Serial No.: 09/928,038

Method of and Apparatus for
Wave Energy Conversion Using
A Float with Excess Buoyancy

[PROPOSED] RESPONSE TO OFFICE ACTION

FIG. 3 A

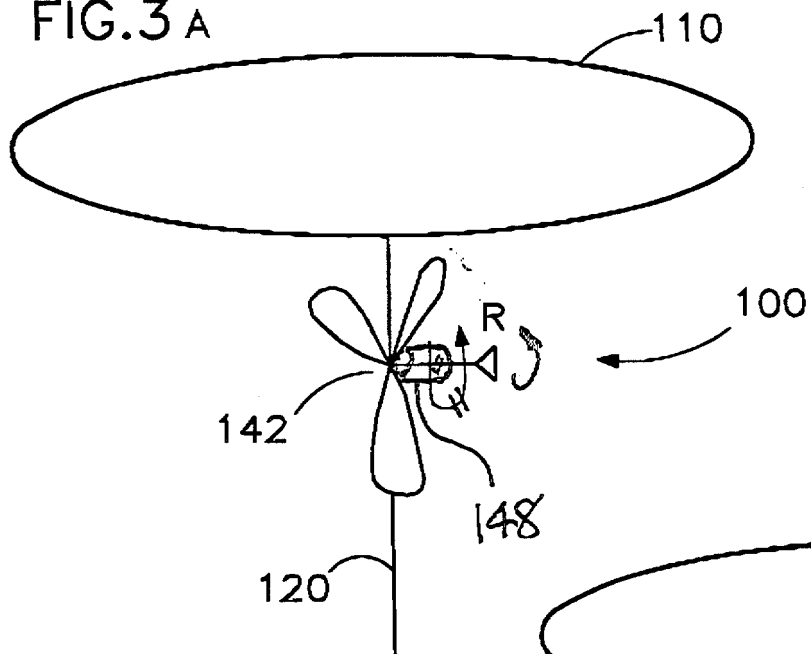
13
14 4.1.2 *Figure 3A, reference 142:*

16
17 4.3 The Examiner's objections to the drawings concerning the
18 showing of the electric generating means and the counterweight
19 are addressed as follows:

15 In the original text of the third paragraph on page
16 14 of the Specification, "turbine 142" was recited.

20 Figure 3A and the corresponding third paragraph on page
21 14 of the Specification have been amended to show the electric
22 generator 148 attached to the tether 120. Figure 3C and the
23 corresponding fifth paragraph on page 14 of the Specification
24 have been amended to show the electric generator 148 attached
25 to the float 110. No new matter is introduced. A sheet of
26 drawings containing Figures 3A and 3C with proposed drawing
27 correction is submitted, along with the Request for Approval of
28 Drawing Correction concurrently filed herewith. The

FIG. 5A

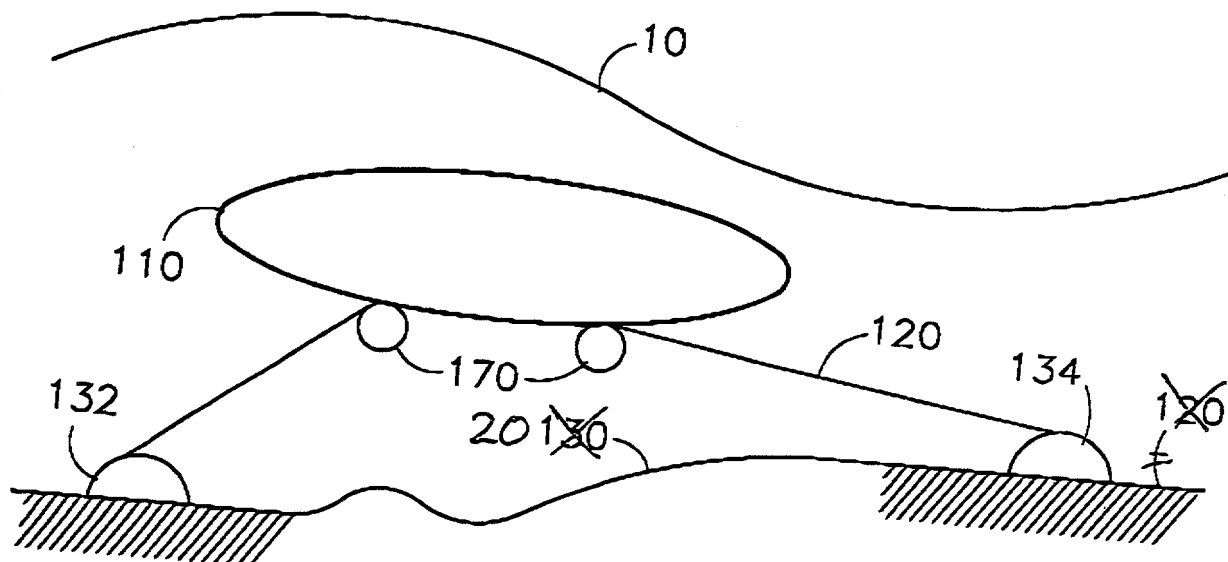
26
27 4.1.4 *Figure 5A, references 130, 132 and 134:*

8
9 4.2 The Examiner's Objection to the drawings concerning reference
10 130 in Figures 5A and 5B is addressed as follows:

1 Specification has been amended to recite that "in Figure
2 5A, the tether **120** is moored to the ocean floor **20**
3 by moorings **132** and **134** at its two opposite ends" as
4 originally shown in Figure 5A. The reference numeral
5 **130** in both Figures 5A and 5B has been corrected to
6 reference numeral **20** which points to the ocean floor.
7 The duplicate reference numeral **120** at the far right end
8 of Figure 5A is deleted. A sheet of drawings containing
9 Figures 5A and 5B with proposed drawing correction is
10 submitted, along with the Request for Approval of
11 Drawing Correction concurrently filed herewith.

11 Reference numeral 130 in both Figures 5A and 5B has
12 been corrected to 20 which points to the ocean floor. A sheet of
13 drawings containing Figures 5A and 5B with proposed drawing
14 correction is submitted, along with the Request for Approval of
15 Drawing Correction concurrently filed herewith.
